<b>DART AEROSPACE LTD</b>	<b>Work Order:</b> 99876
<b>Description:</b> Crosstube Assembly	<b>Part Number:</b> D206-667-243
<b>Inspection Dwg:</b> D206-667-243 Rev: C	<b>Page 1 of 2</b>

DESIGN	9	<b>DART AEROSPACE LTD</b>
DRAWN	RF	HAWKESBURY, ONTARIO, CANADA
CHECKED	CP	DRAWING NO. REV. C
MFG. APPR.	EP	D206-667-243 SHEET 3 OF 4
APPROVED	14P	TITLE SCALE
DE APPR.	14P	CROSSTUBE ASS'Y (206L HIGH AFT) NTS
DATE	08.11.06	COPYRIGHT © 2000 BY DART AEROSPACE LTD
THIS DOCUMENT IS PRIVATE AND CONFIDENTIAL AND IS SUPPLIED ON THE EXPRESS CONDITION THAT IT IS NOT TO BE USED FOR ANY PURPOSE, OR COPIED OR COMMUNICATED TO ANY OTHER PERSON WITHOUT WRITTEN PERMISSION FROM DART AEROSPACE LTD

DRAWING NO. D206-667-243	TITLE CROSSTUBE ASS'Y (206L HIGH AFT)	REV. C	<b>DART AEROSPACE LTD ENGINEERING ORDER</b>		D.E.O. NO. D206-667-243-C-1	SHEET NO. SHEET 1 OF 1	SCALE NTS
DRAWN <i>q</i>	CHECKED <i>ASS</i>	MFG. APPR. <i>RB</i>	APPROVED <i>MP</i>	DE APPR. <i>#</i>			
DATE 11.07.15	DATE 11.07.20	DATE 11.07.21	DATE 11/07/21	DATE 11.07.21

REPLACE MAGNOBOND WITH PROSEAL.

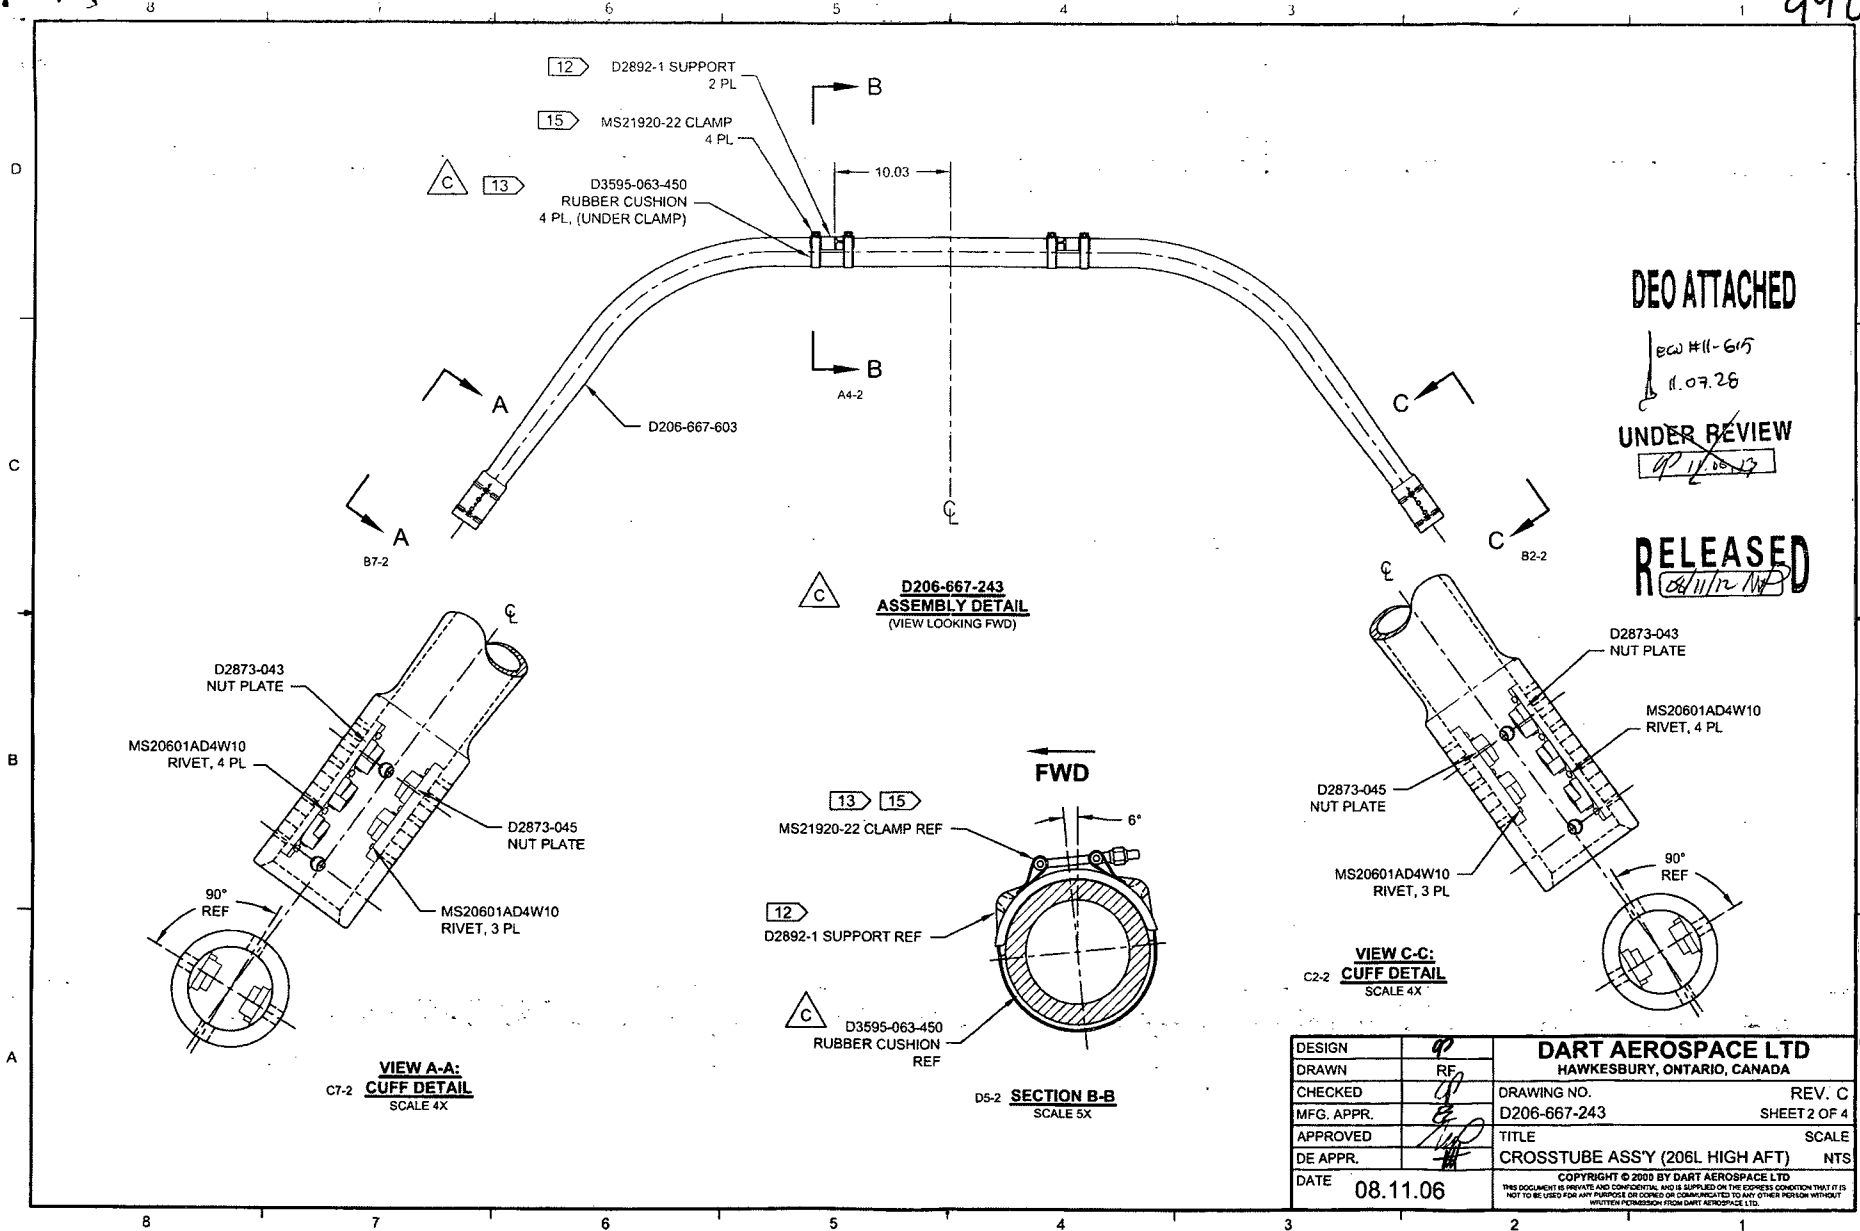
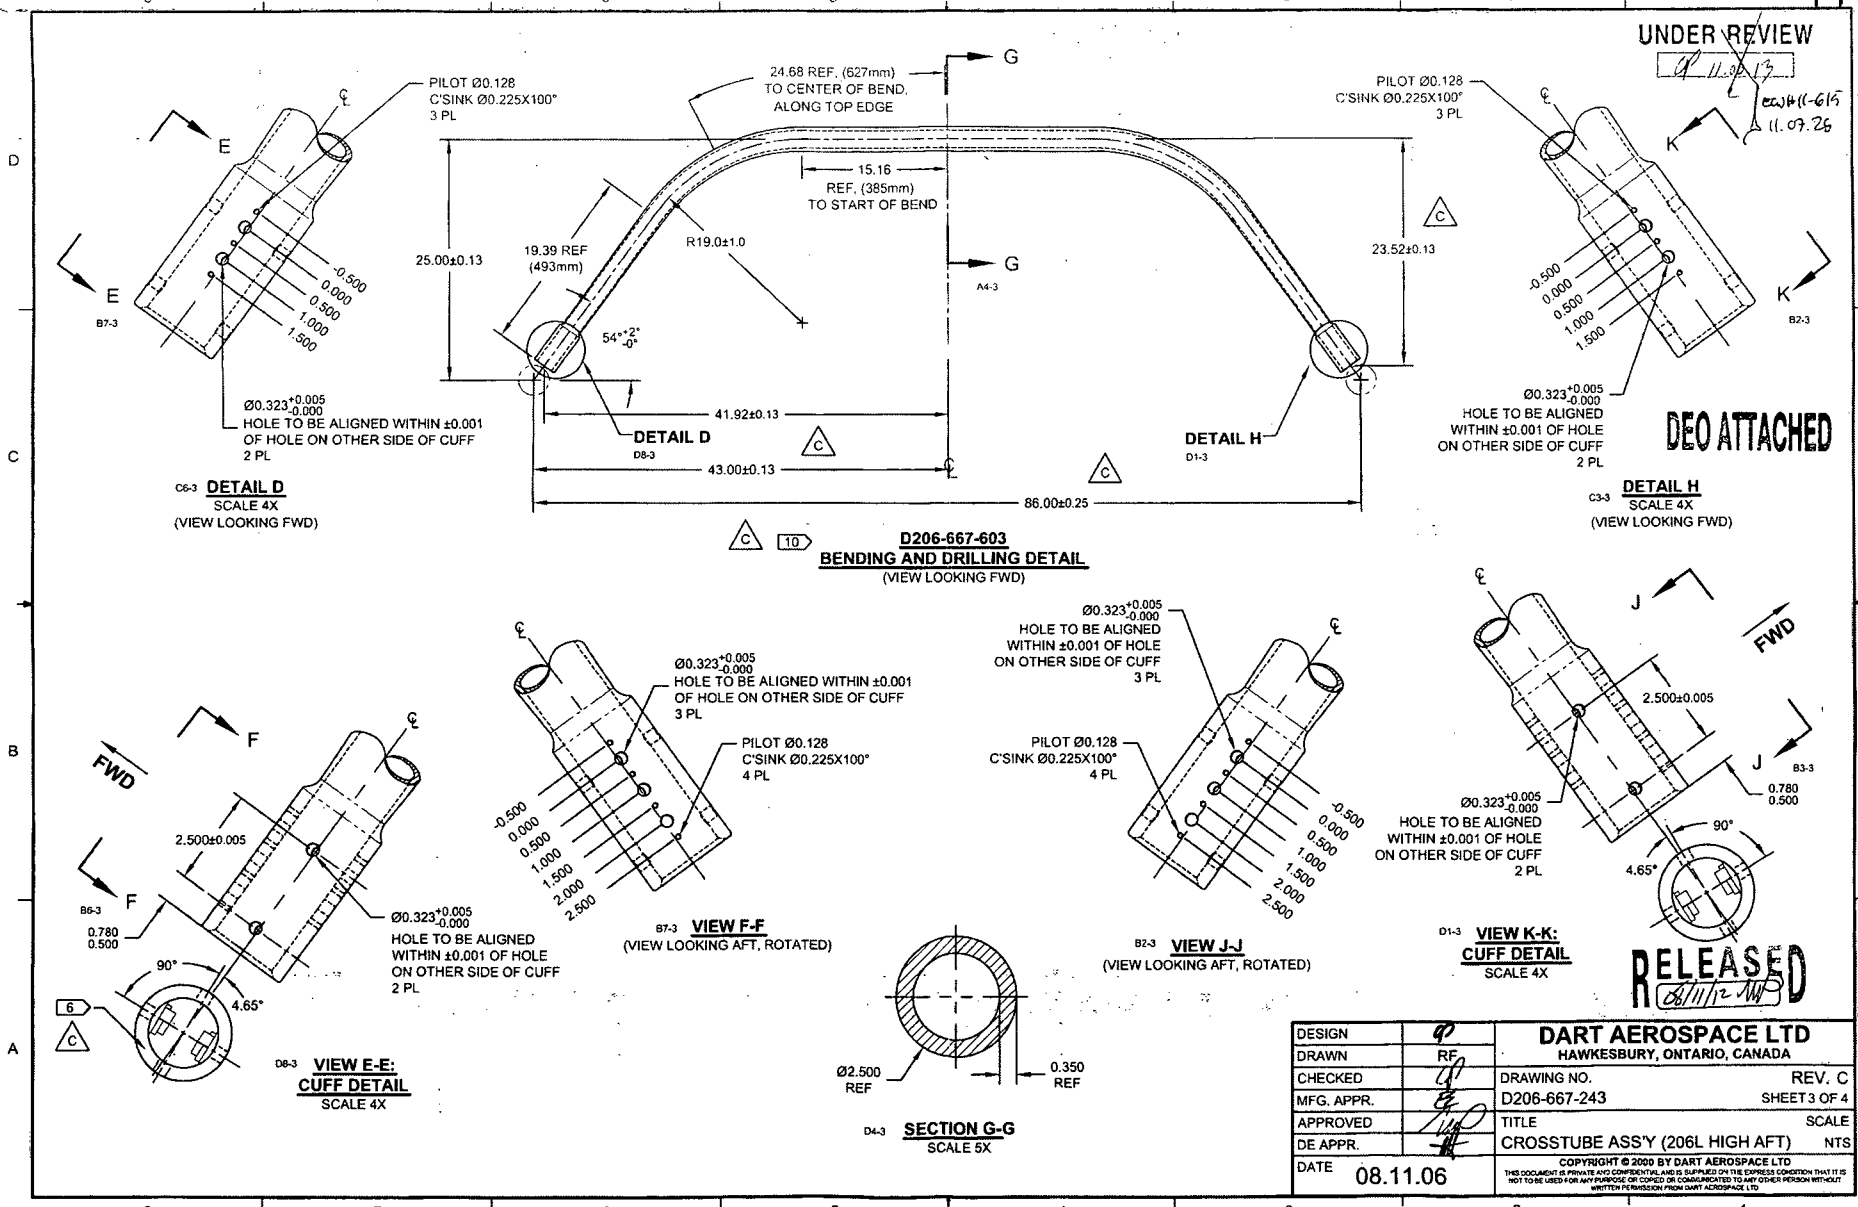
C	REVISE GENERAL NOTES/PART LIST (ZN D7-1); REORGANIZED VIEWS AND REFORMATTED DRAWING TO CURRENT STANDARDS. D3595-063-450 WAS D2858-400-773 (ZN D6-2 & A5-2); REMOVED REF: & ADD TOLERANCES (ZN 4-3, C5-3, D3-3); RELOCATED FLAG #6 (ZN A8-3) PER NCR 210; MOVED TURNING DETAIL & UPDATED TOLERANCE TO SHEET 4.	RF	08.11.06
B	ADD HOLES AND NUT PLATES FOR COMPATABILITY WITH BHT/AA SKUDTUBES	PH	05.07.26
A	NEW ISSUE	CP	00.11.17
REV.	DESCRIPTION	BY	DATE
DESIGN	RF	DART AEROSPACE LTD HAWKESBURY, ONTARIO, CANADA	
DRAWN	RF	DRAWING NO. REV. C D206-667-243 SHEET 1 OF 4	
CHECKED	RF	TITLE SCALE CROSSTUBE ASSY (206L HIGH AFT) NTS	
MFG. APPR.	RF	COPYRIGHT © 2000 BY DART AEROSPACE LTD THIS DOCUMENT IS PRIVATE AND CONFIDENTIAL AND IS SUPPLIED ON THE EXPRESS CONDITION THAT IT IS NOT TO BE USED FOR ANY PURPOSE OR COMMUNICATED TO ANY OTHER PERSON WITHOUT WRITTEN PERMISSION FROM DART AEROSPACE LTD.	
APPROVED	RF	DATE 08.11.06
